**SUBDIVISION, PLANNING APPROVAL &
SIDEWALK WAIVER STAFF REPORT****November 3, 2022****APPLICANT**City of Mobile Board of Water and Sewer Commissioners
(Billy Joe McCrory, Agent)**SUBDIVISION NAME**

Nortons Lane Subdivision

Subdivision Approval to create two (2) legal lots of record from one (1) metes-and-bounds parcel and six (6) legal lots of record, Sidewalk Waiver to waive construction of a sidewalk along Navco Road and Nortons Lane, and Planning Approval to allow the construction of two (2) storm water attenuation tanks in an R-3, Multi-Family Residential District.

SITE PLAN

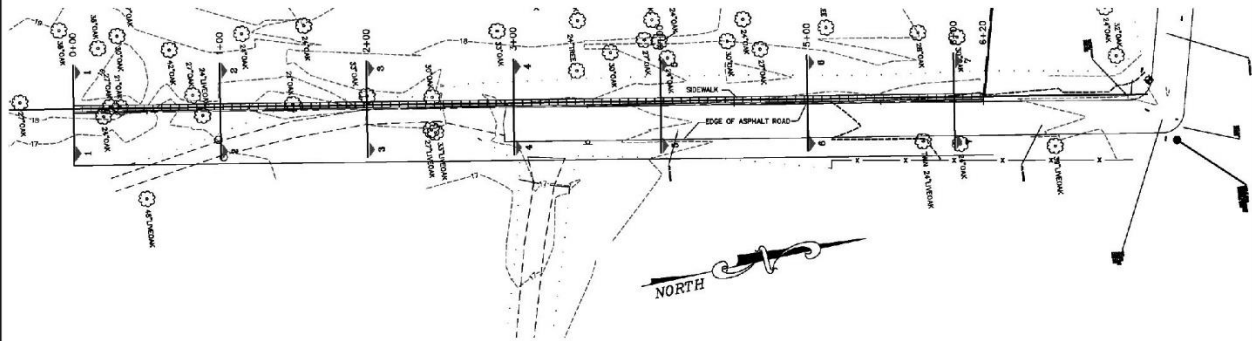
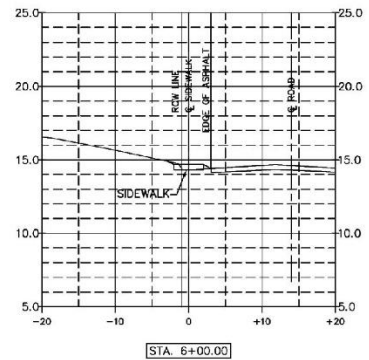
A 25-foot radius curve should be dedicated at the intersection of the two portions of Nortons Lane. The plat indicates the 25-foot minimum building setback line for Lot 1 along Navco Road where the lot is only 50-feet wide. The plat should be revised to illustrate the 25-foot minimum building setback line blocked-out as measured from where Lot 1 is at least 60-feet wide. Both proposed lots meet the minimum size requirements of the Subdivision Regulations. It should be noted that the lot size label for Lot 1 on the preliminary plat incorrectly indicates 13.33± acres instead of 14.33± acres. The lot size labels in both square feet and acres should be retained on the Final Plat, adjusted for any required dedication, or a table should be furnished on the Final Plat providing the same information.

The site plan illustrates two (2) proposed 250-foot± diameter stormwater attenuation tanks with an access drive off the Eastern portion of Nortons Lane leading to a drive around and between both tanks. No driveway dimensions or surfacing information is provided on the site plan. Therefore, the site plan should be revised to indicate a drive with compliant width and paving surface. The site plan does not reflect any dedications or revisions which may be required by the Subdivision review, and the site plan should be revised to reflect such. In particular, the 25-foot minimum building setback line revision required for dedication may impact the location of the Southern tank.

A buffer of varying width (50-foot minimum) is indicated on the site plan, but its type is not identified. The site plan should be revised with a note stating that the buffer will remain in an undisturbed, vegetative state. No landscaping or tree planting calculations are provided on the site plan. As the North, West and South sides of the site contain a buffer of at least 50-feet, which should remain wooded and undisturbed, only frontage trees should be required along the North-South segment of Nortons Lane.

No fencing is indicated on the site plan. If fencing is to be provided, the site plan should be revised to indicate such, with a note on the site plan stating that fencing shall not exceed eight (8) feet in height. Only chain link fencing more than three (3) feet in height would be allowed within the 25-foot minimum building setback along any frontage. No access gate is indicated at the entrance drive. If a gate is to be provided, the site plan should be revised to indicate such, with either the gate set back to allow a 60-foot vehicle queuing space from the front property line within the property, or the placement of a note on the site plan stating that the gate will be electrically operated.

The East side of Navco Road: *There is no sidewalk along Navco Road between Cottage Hill Road and McVay Drive North. Since the subject property is less than 100' wide we are requesting a Sidewalk Waiver.*

The West side of Nortons Lane that runs North-South: *That portion of Nortons Lane dead ends about halfway down the subject property and primarily provides access to the fenced property on the East side of Nortons Lane. There are several piles of debris. There are no structures/destinations for pedestrians along this portion of Nortons Lane and no reason to encourage foot traffic in this area.*

pedestrian traffic, but rather physical limitations and restriction of the site itself which would make the provision of a sidewalk undesirable. Additionally, sidewalks are not intended to serve just current development, but will serve for future development and connectivity. As per the Engineering comments concerning both areas for which the waiver is requested, it appears that there is sufficient room within the ROW, or within the property, for the construction of a sidewalk that could be approved through the ROW Permit process.

- 1) revision of the site plan to indicate a drive with compliant width and paving surface;
- 2) revision of the site plan to indicate dedication to provide 25-feet from the centerline of the North-South segment of Nortons Lane where currently less;

- 3) retention of the right-of-way labels of all street, after any required dedication;
- 4) revision of the site plan to indicate the 25-foot radius curve dedicated at the intersection of the two segments of Nortons Lane;

- 5) revision of the site plan to illustrate the 25-foot minimum building setback line along Navco Road for Lot 1 blocked-out as measured from where that lot is at least 60 feet wide;

- 6) revision of the site plan to illustrate the 25-foot minimum building setback line as measured from any required dedication;
- 7) retention of the lot size labels in both square feet and acres, or the furnishing of a table on the site plan providing the same information, after any required dedication;

- 9) revision of the site plan to include a note on the site plan stating that the buffer will remain in an undisturbed vegetative state;
- 10) revision of the site plan to provide landscaping and tree planting calculations, and provision of frontage trees along the North-South segment of Nortons Lane;

- 11) revision of the site plan to indicate any proposed fencing, with a note on the site plan stating that fencing shall not exceed eight (8) feet in height, and only chain link fencing more than three (3) feet in height is allowed within the 25-foot minimum building setback along any street frontage;

- 12) if an entrance gate is to be provided, revision of the site plan to indicate such and provide a 60-foot vehicular queuing space back from the front property line within the property, or the placement of a note on the site plan stating that the gate will be electrically operated;

- 13) revision of the site plan to depict a sidewalk along Navco Road and the North-South segment of Nortons Lane in the event the Sidewalk Waiver is not approved;
